APPLICATION NO.	FILING DATE	FIRST NAMED INVENTOR	ATTORNEY DOCKET NO.	CONFIRMATION NO.
10/508,981	09/24/2004	Gerhard Mock	04-439	1111

Office Action Summary	Application No. 10/508,981	Applicant(s) MOCK, GERHARD	
	Examiner Luan K Bui	Art Unit 3728

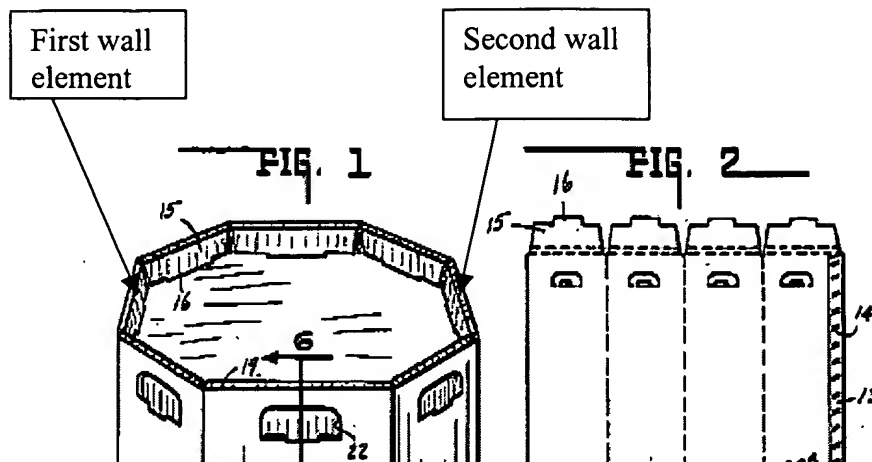
2. The specification is objected to under 37 CFR 1.71, as failing to provide an adequate written description of the invention and failing to adequately teach how to make and/or use the invention, i.e. failing to provide an enabling disclosure because the specification does not enable any person skilled in the art to which it pertains, or with which it is most nearly connected, to make and/or use the invention. The application fails to sufficiently describe the folding steps that how Figure 1 can become Figures 3-5 especially the gap 52, stamped edges 48, 50, stiffening means 56, 58 (the line in Figure 3) and others.

3. Claims 20-31 are rejected under 35 USC 112, first paragraph, as failing to comply with the enablement requirement. The claim(s) contains subject matter which was not described in

the specification in such a way as to enable one skilled in the art to which it pertains, or with which it is most nearly connected, to make and/or use the invention.
